Access Compliance Report Public Rights-of-Way (Curb Ramps)

Main Street: CASTLEGATE_LN **Cross Street:** CASTLEGATE_LN **Location:** E

ADA ID: RPRK211011111548 **Ramp Type:** Type 1 - Perpendicular Diagonal Initial Pass/Fail: Fail **Overall Compliance:** No **Severity Score:** 15

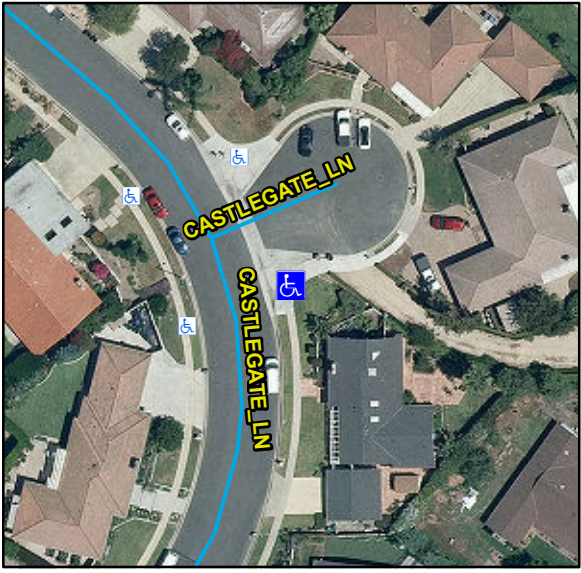
Compliance	Description	Data	Compliance	Description	Data
N/A	Ramp Length (in)	104	N/A	Flare Type LT	
Yes	Ramp Width (in)	48			N/A
No	Ramp Run Slope (%)	9.9	N/A	Flare Slope LT (%)	N/A
Yes	Ramp Cross Slope (%)	0.4	N/A	Flare Traversable LT	N/A
N/A	Landing Present	N/A	N/A	Flare Type RT	
N/A	Landing Length (in)	N/A			N/A
N/A	Landing Width (in)	N/A	N/A	Flare Slope RT (%)	N/A
N/A	Landing Run Slope (%)	N/A	N/A	Flare Traversable RT	N/A
N/A	Landing Cross Slope (%)	N/A	N/A	DWS Provided	N/A
N/A	Landing Movement Obstructed?	N/A	N/A	DWS Contrast	N/A
	Landing Movement Type	N/A	N/A	DWS Length (in)	N/A
N/A	Landing Shared	N/A	N/A	DWS Full Width	N/A
N/A	Clear Space	Yes	N/A	DWS Offset Left (in)	N/A
N/A	Clear Space To Crosswalk (in)	N/A	N/A	DWS Offset Right (in)	N/A
N/A	Marked Crosswalk 1	No	N/A	Marked Crosswalk 2	No
	Crossing 1 Direction	N		Crossing 2 Direction	W
	Marked Crosswalk 1 Width (in)	N/A		Marked Crosswalk 2 Width (in)	N/A

N/A	Ramp Inside Crosswalk 1	N/A	Yes	Ramp Inside Crosswalk 2	N/A
	Crossing 1 Slope (%)	11.5		Crossing 2 Slope (%)	3.7
	Crossing 1 Cross Slope (%)	2.6		Crossing 2 Cross Slope (%)	2
N/A	Gutter Ponding	N/A	No	Curb Slope	22.1
Yes	Gutter Lip Height (in)	0		Road Run Slope (%)	2.7
N/A	Gutter Run Slope (%)	N/A		Road Cross Slope (%)	1.1
N/A	Gutter Cross Slope (%)	N/A			
Yes	Overall Surface Condition: Acceptable		Yes	Perp Joint Present	Yes
	Cross Gutter Present?	Yes		Spandrel Present?	Yes
	Replace Cross Gutter?	No		Replace Spandrel?	No

Possible Solutions:
Remove & Replace Curb Ramp With Two New Directional Ramps or Equivalent.

OC Std/PROW:
 R304.2.2, STD 1115
